October 31, 2011

**Ingersoll Rand Residential Solutions comments on California Energy
Commission Staff Proposed Amendments to Title-24,
Part 6, Subchapters 2 and 7**

10-BSTD-1

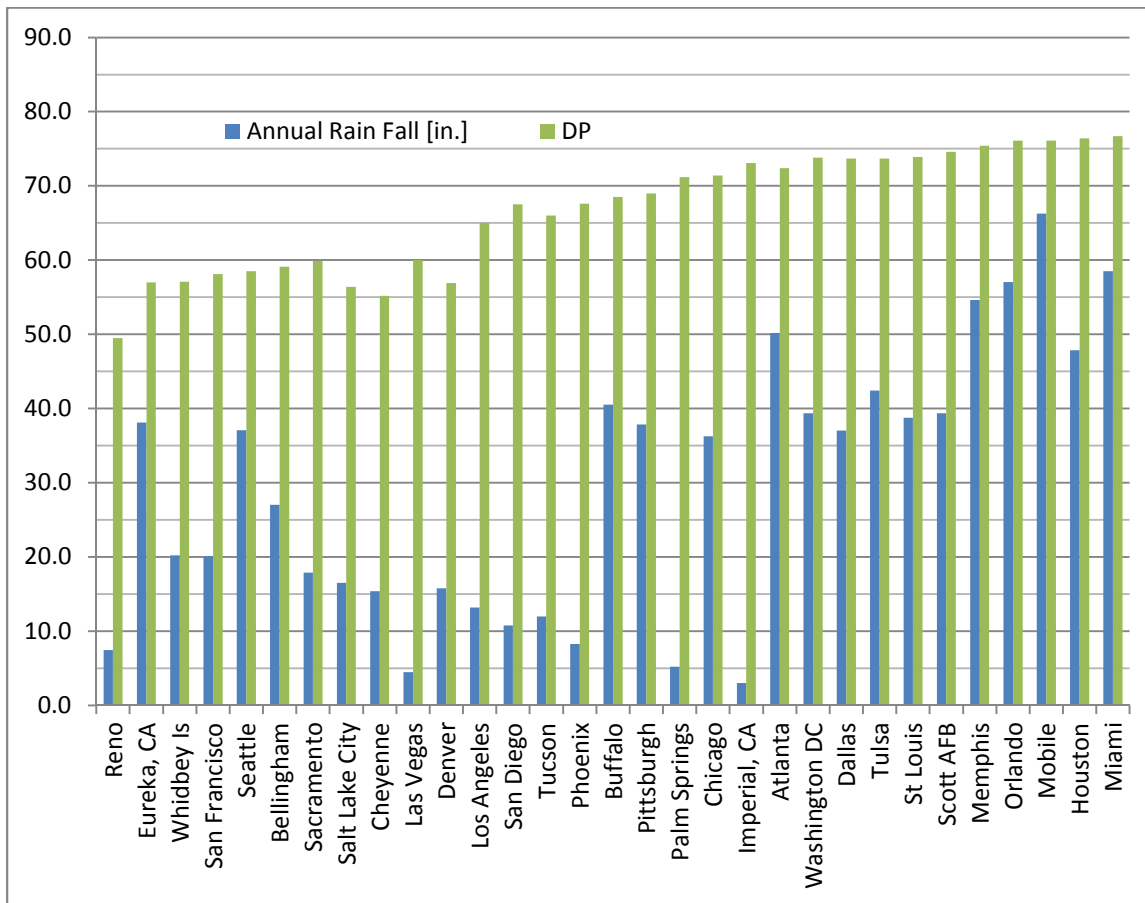
To explain this point, it is first necessary to realize that virtually all places in the continental U.S. require dehumidification at least occasionally. We tend to think of places as having a dry climate if they have little rain. Imperial, California, might be a good example, with about 3 inches of rain per year according to NOAA/NCDC. However, in terms of design dew-point, Imperial lies between Chicago and Atlanta, neither of which would be considered to have a dry climate. [The ASHRAE 2% design dew-points and the annual rain fall for several cities are shown in the chart below.]

The apparent dilemma is explained, at least in part, by the fact that very warm air can contain more moisture than very cool air. So, cool places like Eureka, CA, San Francisco, and Seattle have lower design dew-points than do some desert locations like Tucson, Phoenix, and Palm Springs.

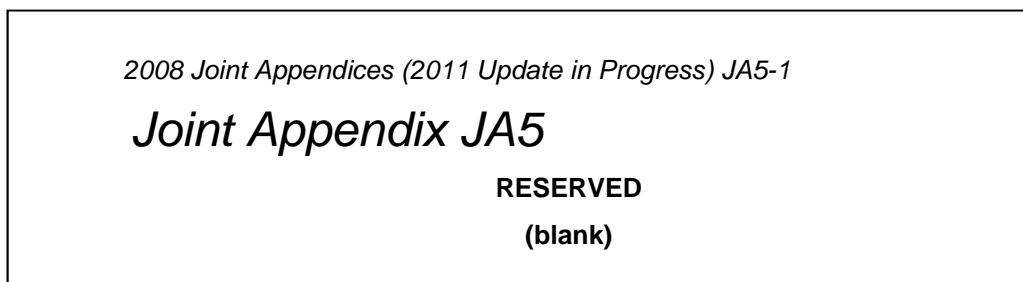
C. “Mapping of terminal numbers 1-6” is unclear.

First, it is important to distinguish between the terminals that connect the UST to an external power source and the controlled equipment, those envisioned for the “standalone indicator”, those for the interface between the UST and the to-be-defined communication module, and possibly those between the UST with communication module and a phone line, cable, or internet connection.

Second, the standard thermostat terminals are identified by an alphabetical code, as illustrated in NEMA DC-3. They are not numbered.
